Attention: Docket ID EPA-HQ-OAR-2023-0434

RE: Waste Emissions Charge for Petroleum and Natural Gas Systems

The American Petroleum Institute, American Exploration and Production Council, American Fuel and Petrochemical Manufacturers, Independent Petroleum Association of America, LNG Allies - The USLNG Association, Energy Workforce and Technology Council, Western States Petroleum Association, Alaska Oil and Gas Association, Kentucky Oil and Gas Association, Louisiana Mid-Continent Oil and Gas Association, Michigan Oil and Gas Association, New Mexico Oil and Gas Association, North Dakota Petroleum Council, Ohio Oil and Gas Association, The Petroleum Alliance of Oklahoma, Pennsylvania Independent Oil and Gas Association, Texas Independent Producers and Royalty Owners Association, Utah Petroleum Association, Gas and Oil Association of West Virginia, and Petroleum Association of Wyoming (collectively, the "Industry Trades") respectfully submit the below comments on the Environmental Protection Agency's (EPA) Proposed Rule "Waste Emissions Charge for Petroleum and Natural Gas Systems" (89 FR 5318, January 26, 2024) ("WEC").

Figure 2. Flowchart of Proposed Follow-up Actions for Periodic Screening Surveys

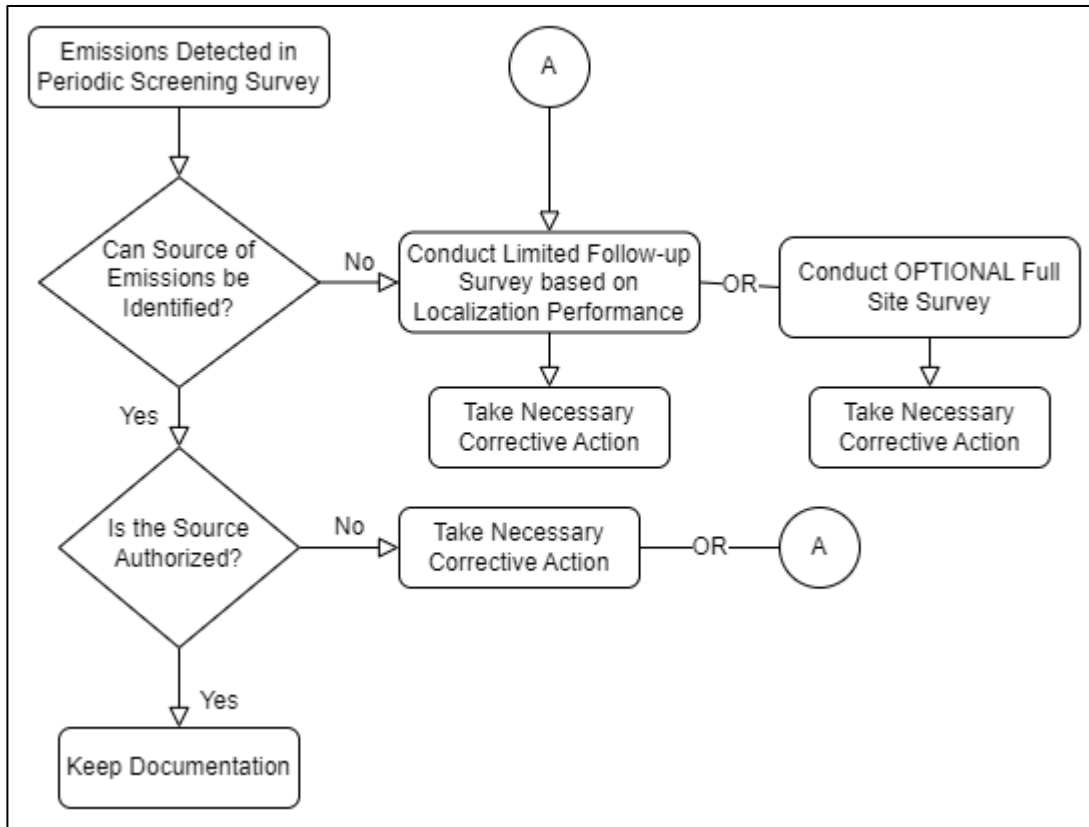
- **EPA should also clarify that limited or full site follow-up OGI surveys should be allowed in response to emissions detected by continuous monitoring depending on the localization performance of the continuous monitor(s).** A limited or full site follow-up OGI survey may be a useful tool in identifying the source of emissions and therefore appropriate corrective actions. API recommends that the proposed follow-up action process for periodic screening surveys based on localization performance also apply to continuous / near continuous monitoring; refer to Comment 3.3.2 and Figure 2 for more details.

Figure 2. Flowchart of Proposed Follow-up Actions for Periodic Screening Surveys

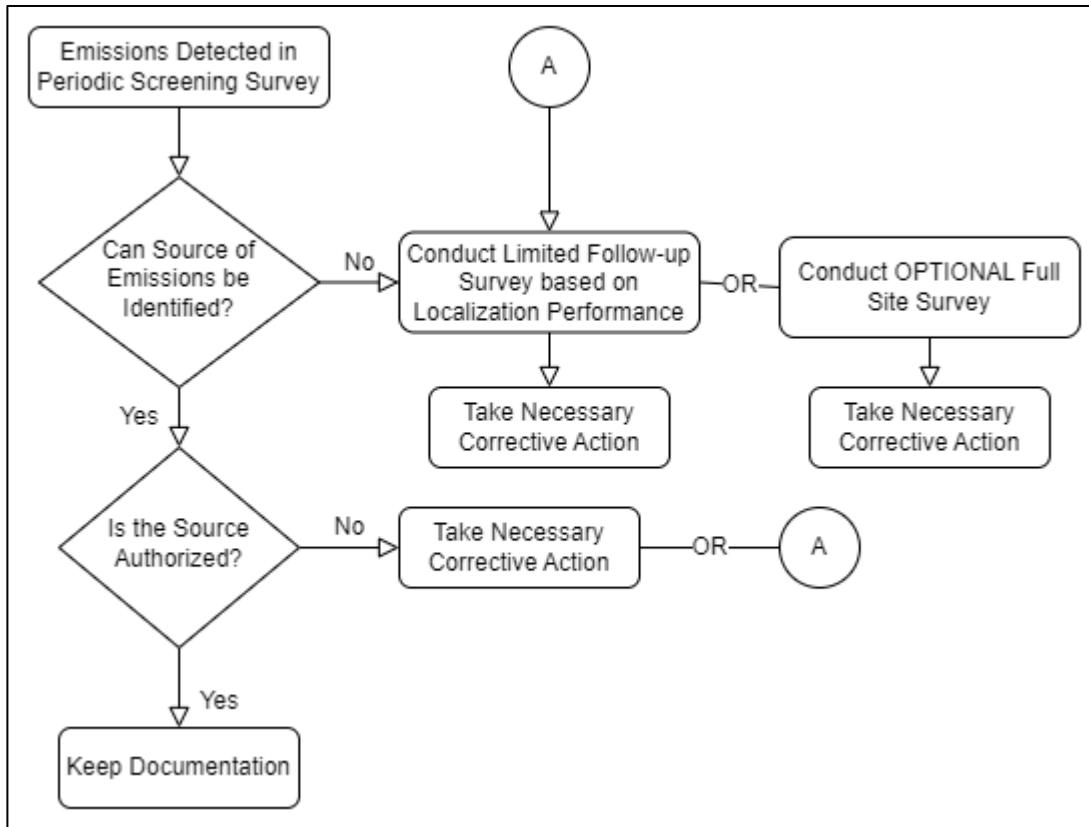
- **EPA should also clarify that limited or full site follow-up OGI surveys should be allowed in response to emissions detected by continuous monitoring depending on the localization performance of the continuous monitor(s).** A limited or full site follow-up OGI survey may be a useful tool in identifying the source of emissions and therefore appropriate corrective actions. API recommends that the proposed follow-up action process for periodic screening surveys based on localization performance also apply to continuous / near continuous monitoring; refer to Comment 3.3.2 and Figure 2 for more details.
